January 16, 2025

ADDENDUM #4

Coastal Carolina Community College
Learning Resources Center
First Floor Renovation
SCO ID: 23-26060-01A

Sheet Title
ELECTRICAL
FIRST FLOOR PLAN -
CABLE TRAY

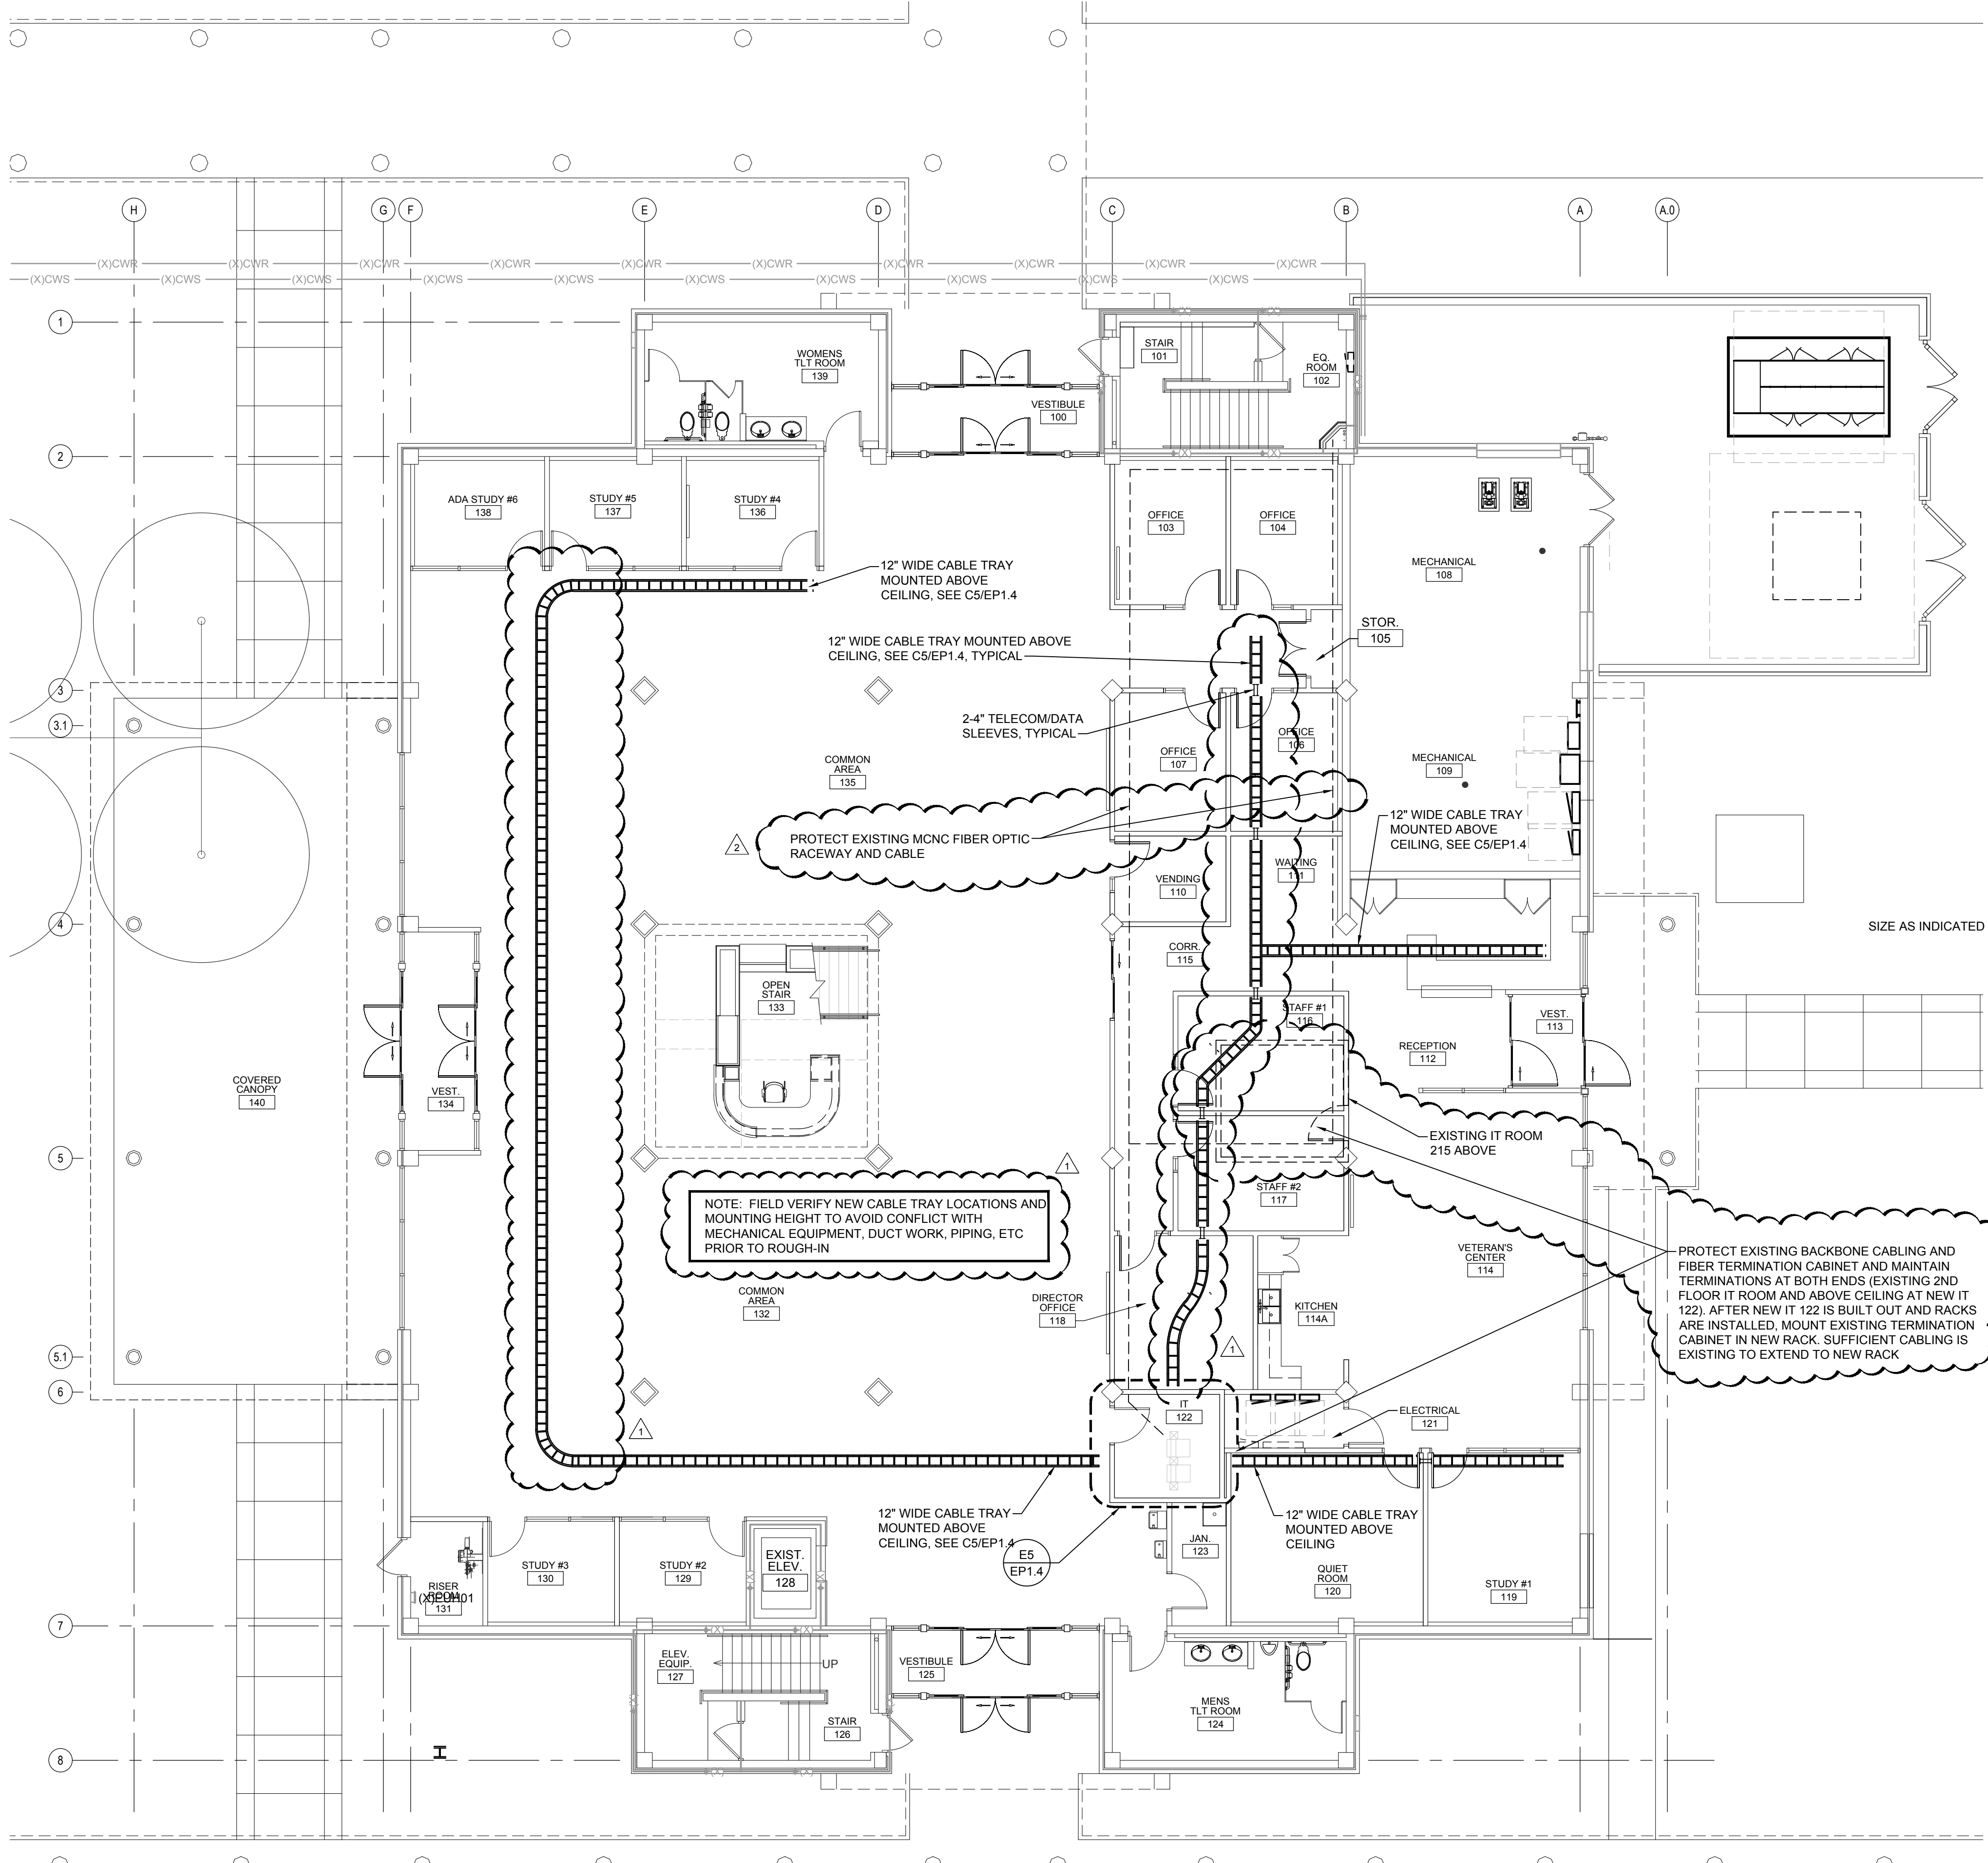
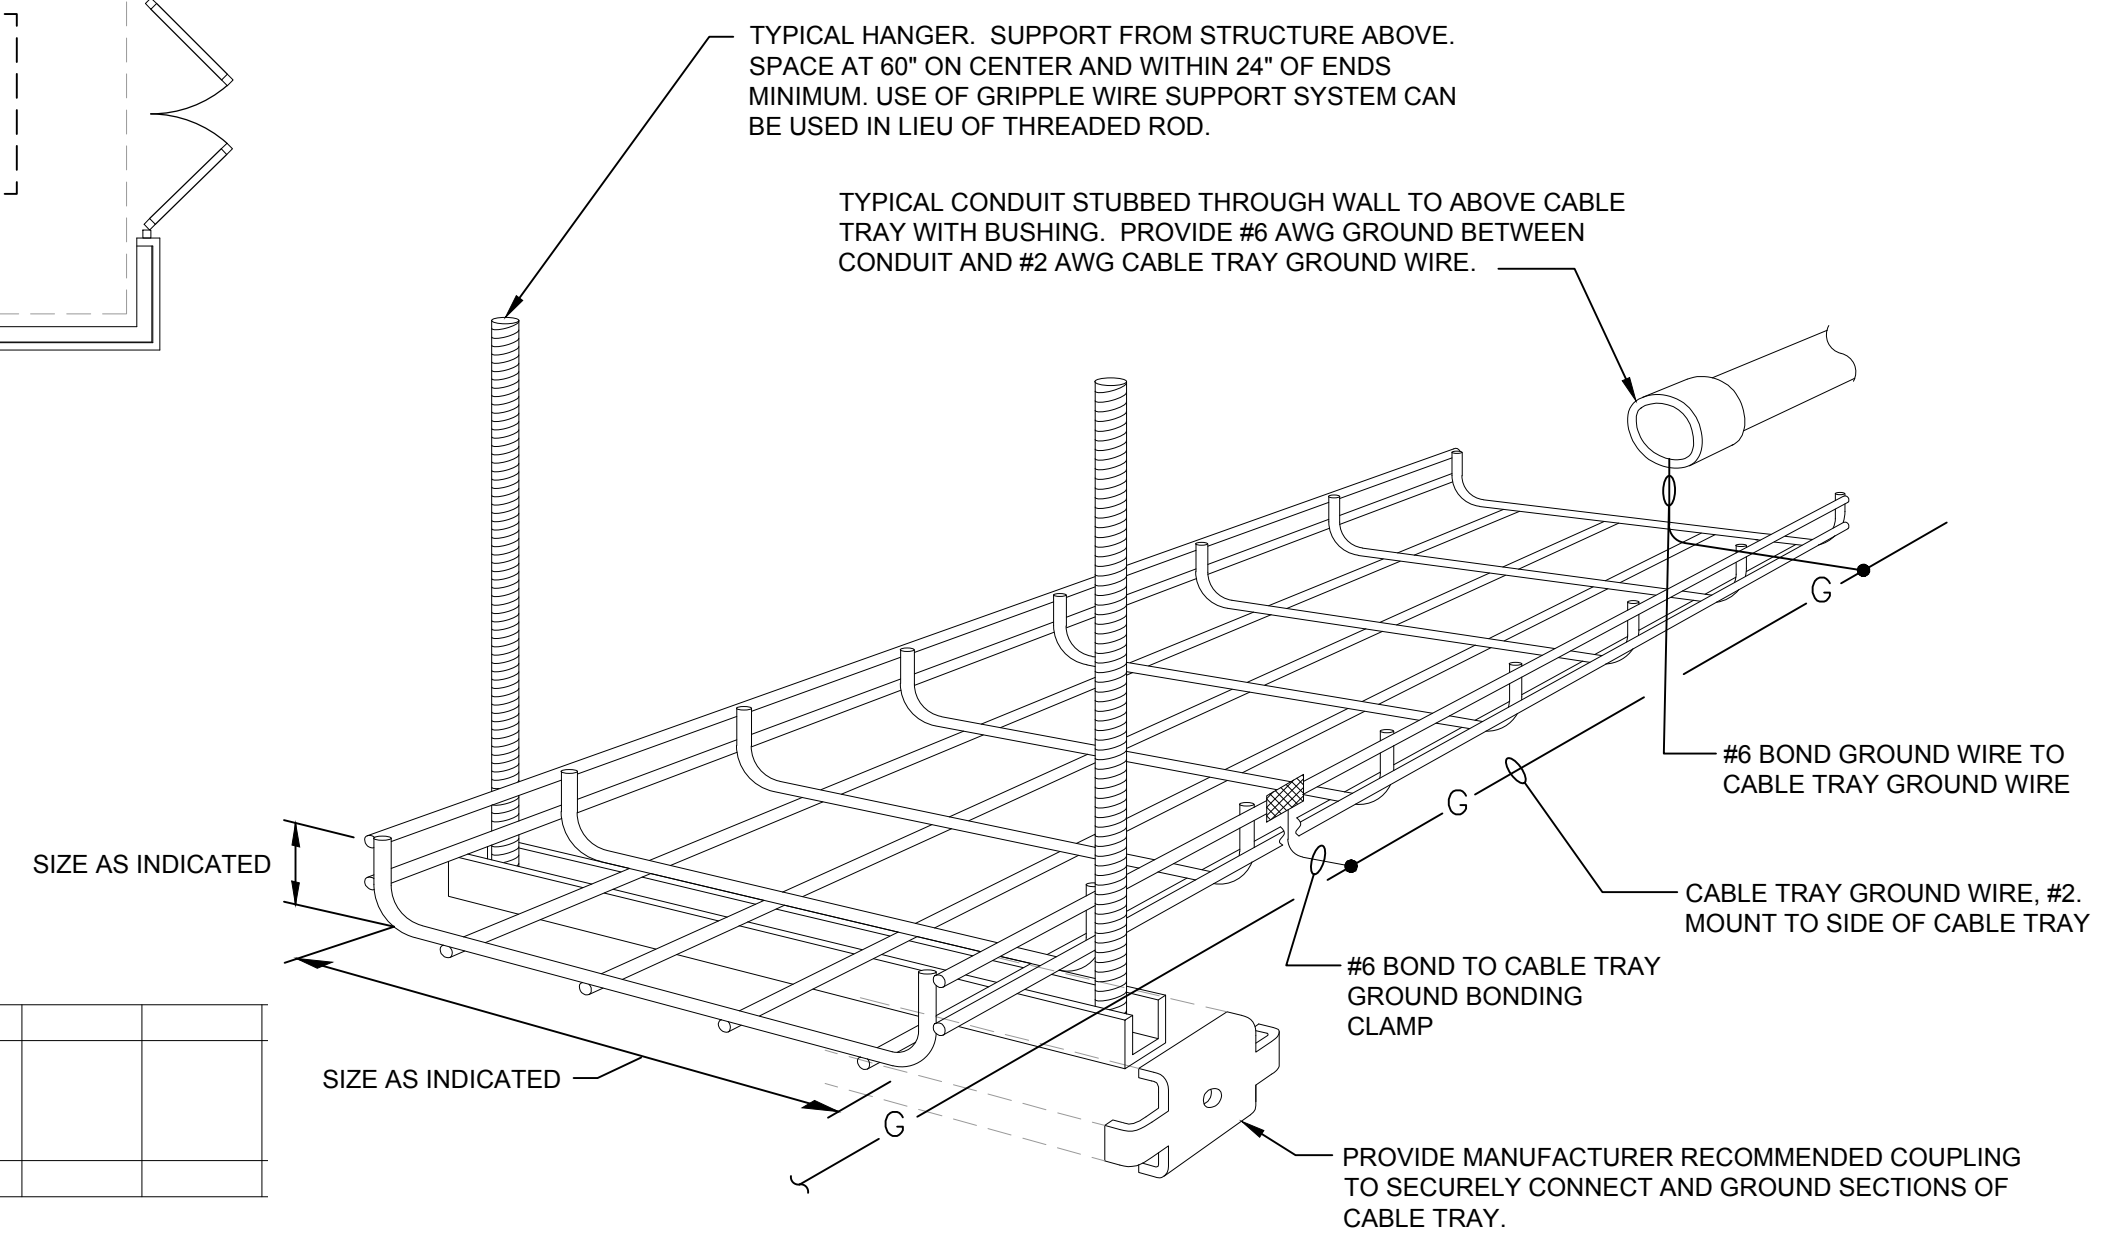
Revised drawing sheet EP1.4 calls for existing MCNC fiber optic raceway and cable to be protected during construction.
